Re: **WEST BLUFF ROAD STABILIZATION PROJECT**  
Architectural Review

This letter is in response to a request from Davidson Hospitality Group to provide a review of a proposed emergency stabilization project to address erosion of the hillside below West Bluff Road near the southwest corner of The Grand Hotel. Long-term and recent more significant erosion of the hillside on hotel property below the road has raised concern as to the safety of this section of West Bluff Road.

Following more detailed engineering, The Grand Hotel proposes to shore up the road by installing an approximately 20 feet high by 150 feet long masonry retaining wall along a section of hillside below the road. The retaining wall would be constructed of precast concrete blocks using a system designed and fabricated by Redi-Rock International, of Charlevoix. It has the general appearance of random stacked stone similar to the natural limestone bedrock underlying and seen in the eroded bluffs found on the Island. This retaining wall system is comprised of ten different molded rock faces cast during fabrication, providing 115 square feet of non-repeating face pattern. The concrete comprising the rock-like block fac

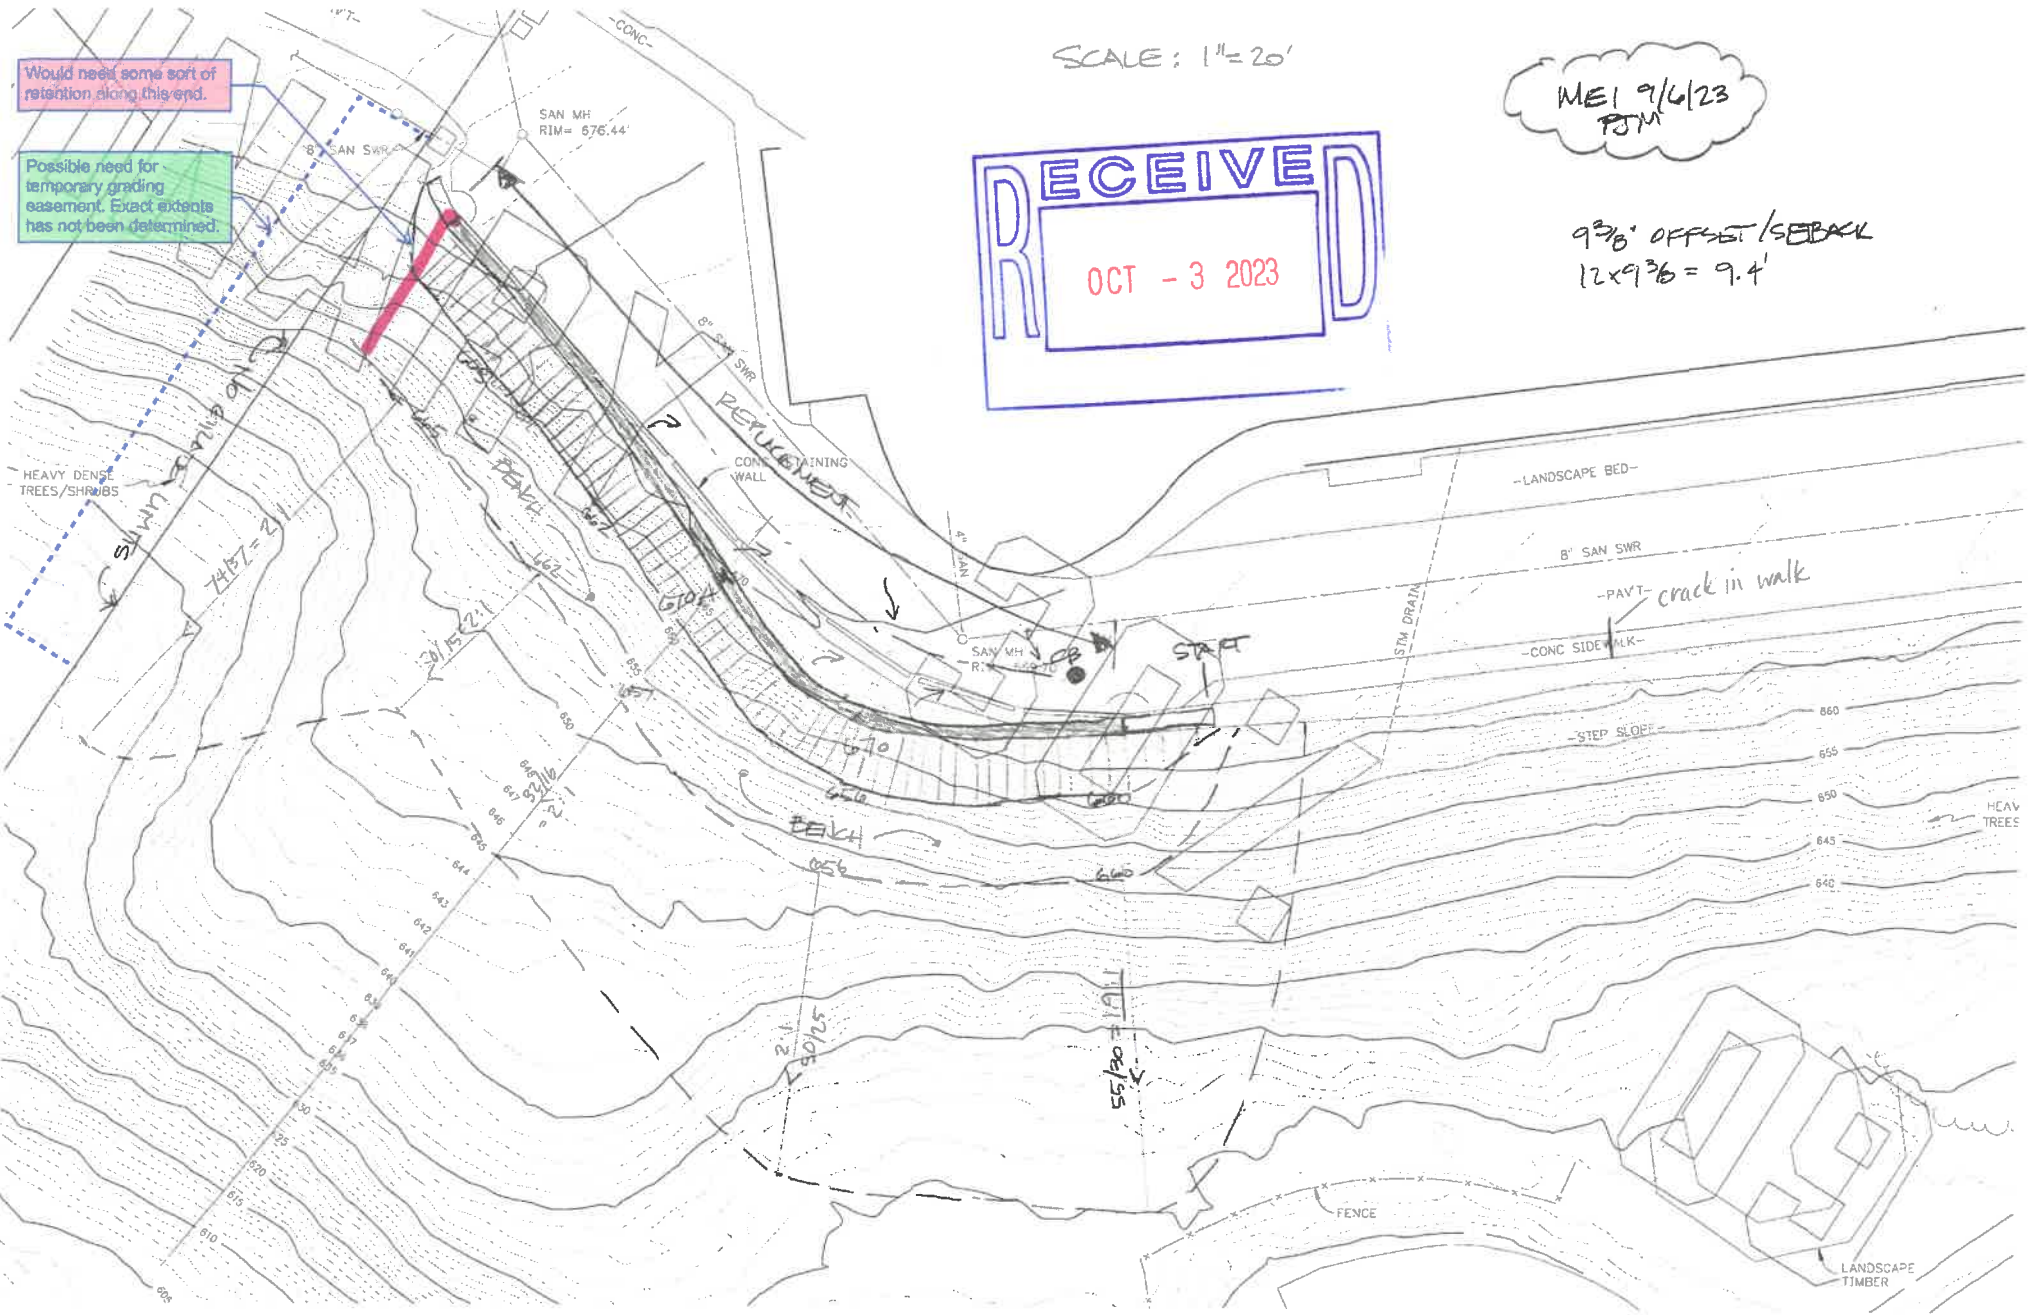
Would need some sort of retention along this end.

Possible need for temporary grading easement. Exact extents has not been determined.
